Response to Public Comments

Proposed 2 Lot Subdivision plus Remainder Parcel

Application M-19-003 400 Surmont Drive -- Lands of Anderson

EXCERPT FROM HSP TRAILS – FIGURE 3

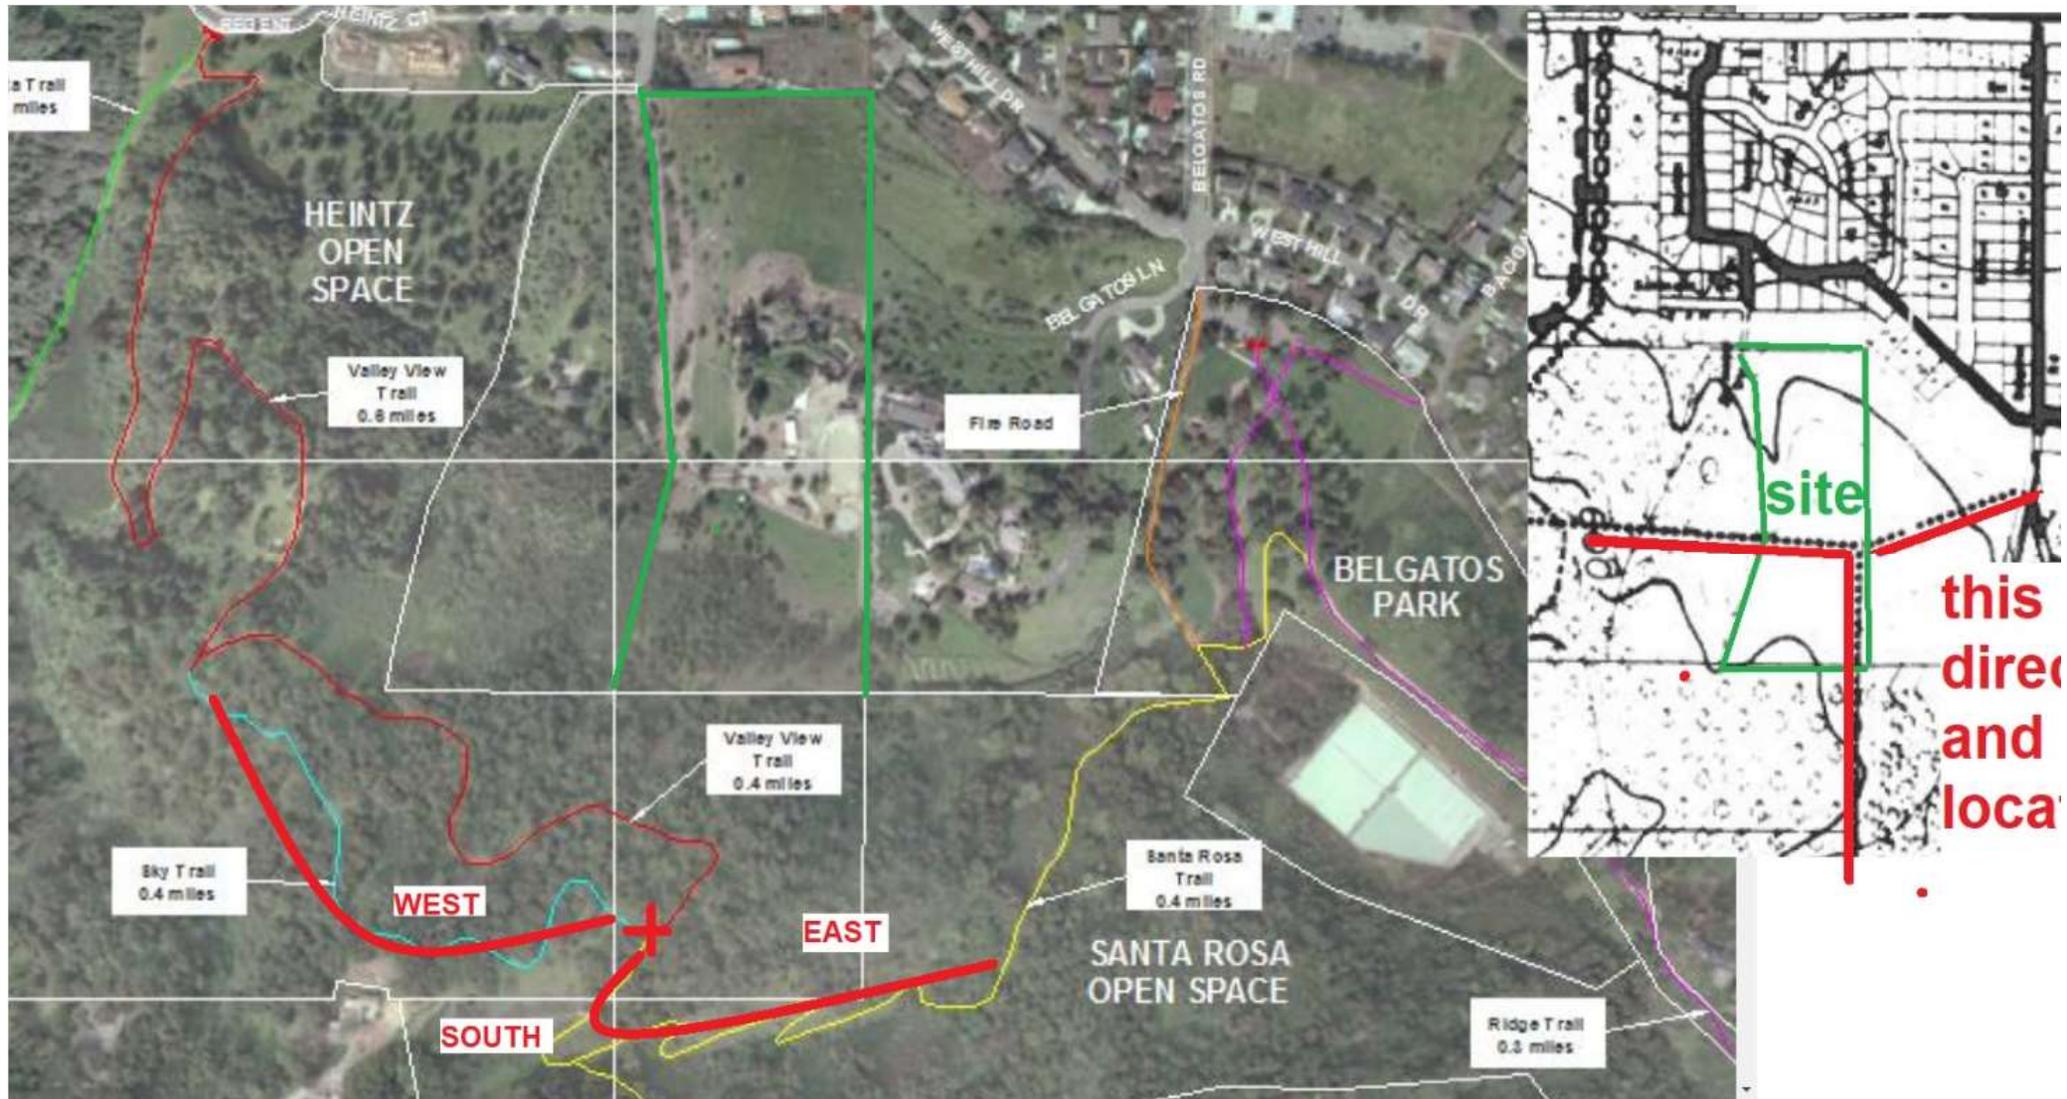
5. *Is dedication of area for trails planned as a part of this proposal?*

- d. *This comment remains outstanding from 4/10/19. Please state in the Letter of Justification / Project Description whether dedication of area for trails is planned as a part of this proposal.*

We have enclosed the "HSP Trails and Open Space -- Figure 3" with our annotations. Please note that the trail locations were drawn on the HSP with the explicit caveat that connection points and general direction were all that could be determined at the "broad brush" level of the HSP. Further refinement of specific trail routes that respect the terrain and residential privacy would be developed and implemented with future subdivision applications. In fact, if you carefully review some of the "County and Los Gatos Trail

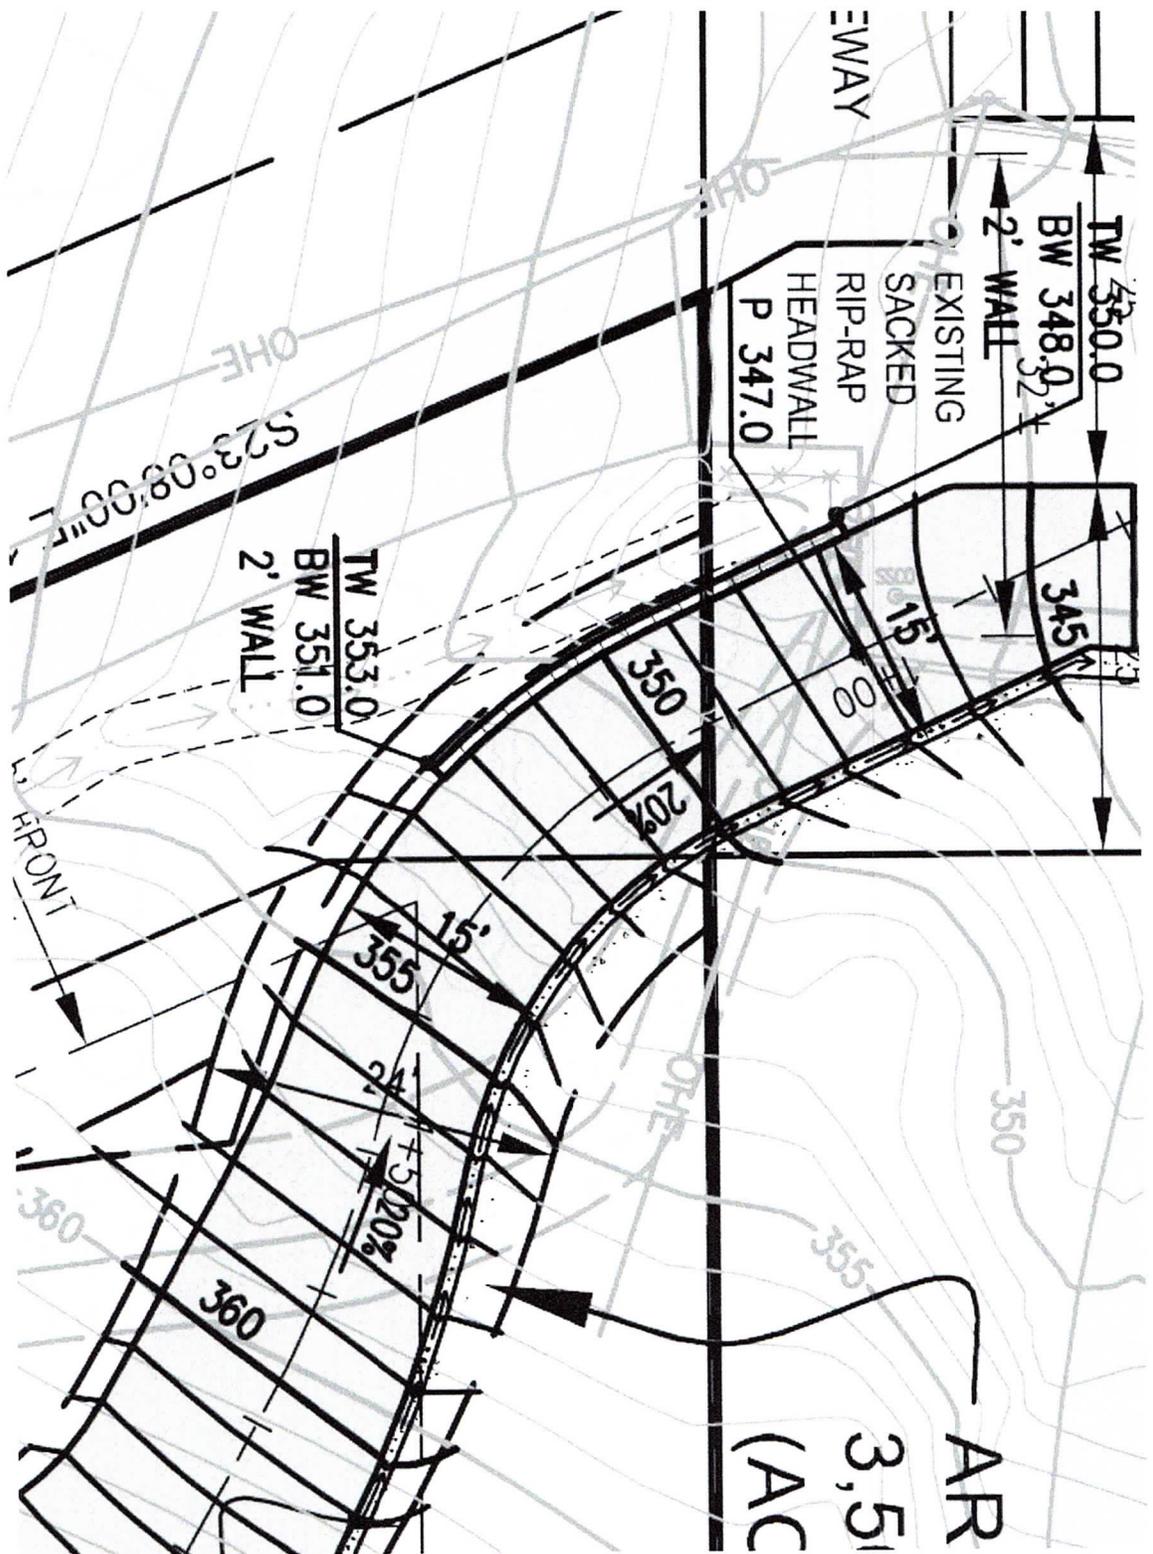
Thank you for the information. Can you confirm that the plans submitted on 8-4-20 are still accurate? Please see attached screenshot of the area in question. Is the proposed driveway location moving closer to the "aquatic feature"?

I spoke with the neighbor at 200 Surmont this afternoon who claims the driveway was moved closer to the aquatic feature.

Ryan, This plan is still accurate. The short retaining wall is in the same place. There simply is no wiggle room there adjacent to the existing barricade, which is at the top of bank--hence the retaining wall.

The purple is consistent with the proposed plans and does not constitute a change to the top of bank setback. My green staking was inaccurate but corrected after we precisely set the critical property corner.

200824 16-233 200 Surmont Town GIS AND NEW ROAD.jpg
575K

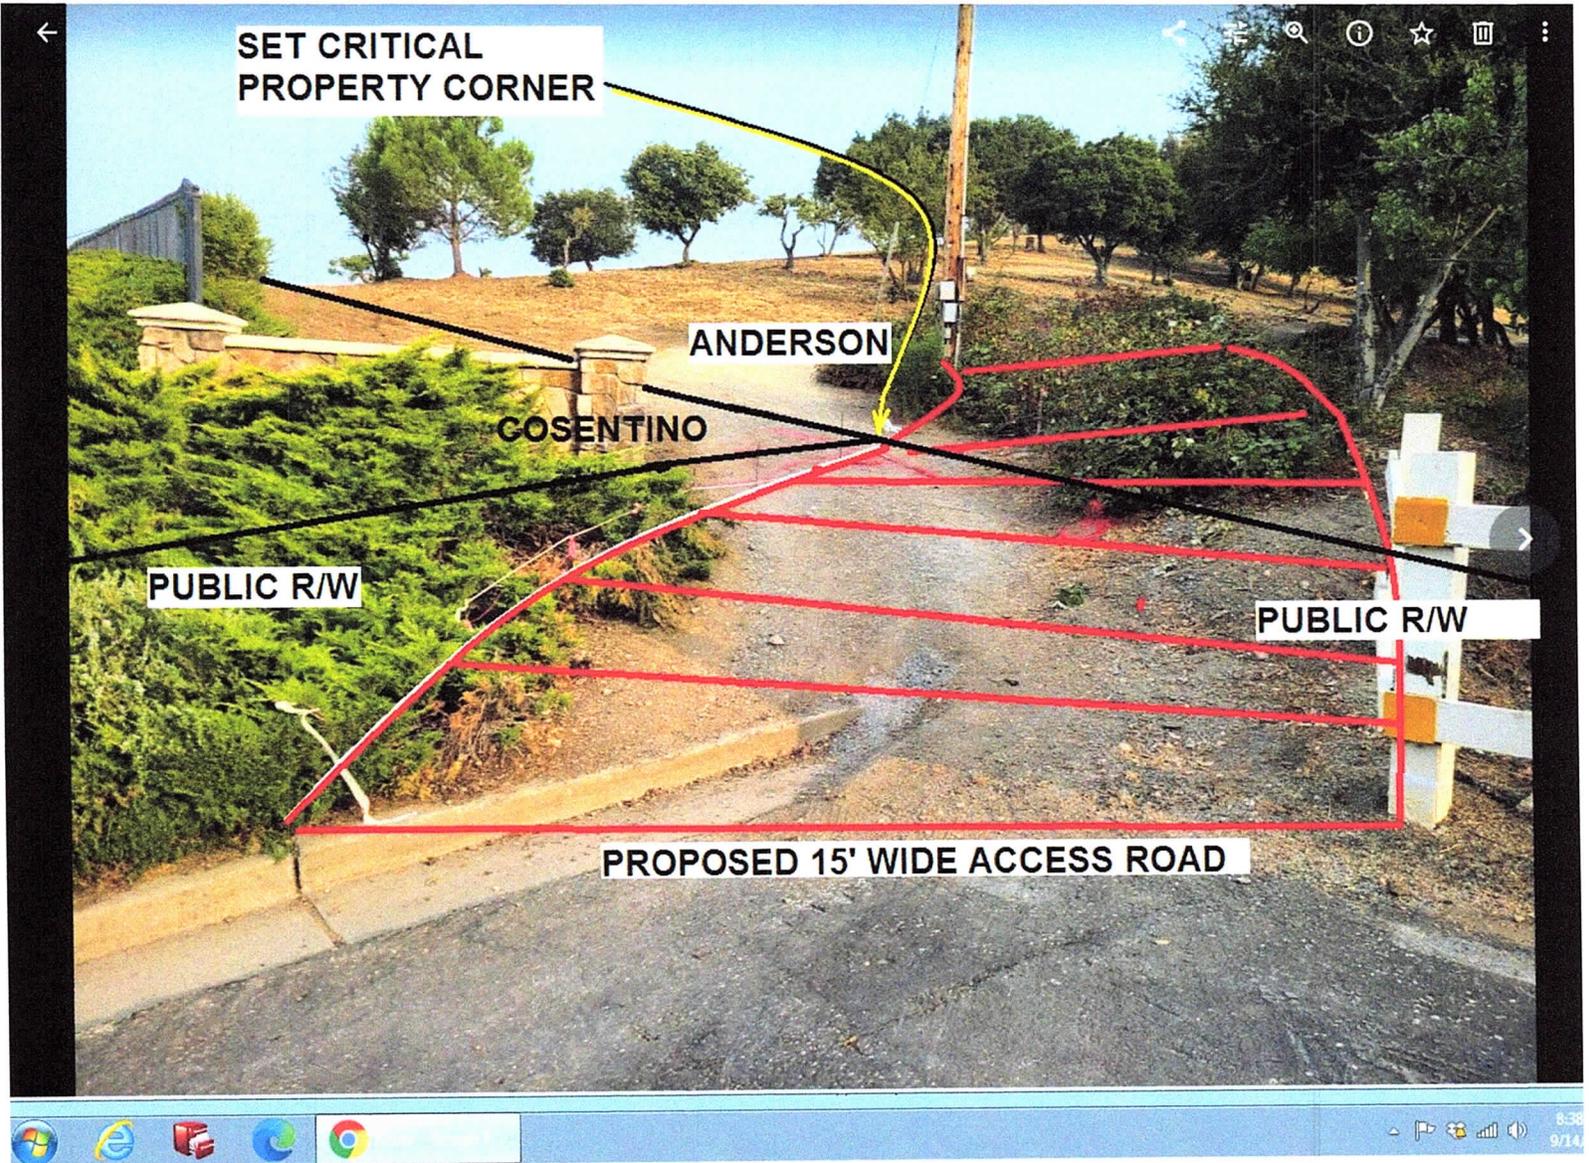
Ryan, I wanted to be sure to report our interaction with our neighbor Paul Cosentino. We had met a few weeks ago to review the mutual property line and the position of the new access road at the terminus of Surmont Dr. Bob Hughes agreed to accelerate the boundary survey for the project and our field crew had good results with finding the 1/4 section corner (our SE) at the top of the property which they tied to centerline Blossom Hill Road and then set the common line between Cosentino and Anderson and the terminus of the public street right of way at Surmont. Cosentino rec'd a free confirmation of their corners.

The true location shifted over some 2' from our previous understanding and we have adjusted the 15' access road in the filed to stay out for the world to see if you care to visit the site. We are still able to respect the swale area bank and will install, as previously planned, the stability at the start of the driveway on the swale side. Please recall that CDFW accepted our Streambed Alteration Agreement applicatio require said agreement due to a lack of impact.

We did also determine that the Cosentino wrought iron fence is about 3' off property line (into their property), which allows for a planting t and our future house on Parcel 1) for their privacy. They can plant and irrigate this on their own property without the need for an easemei
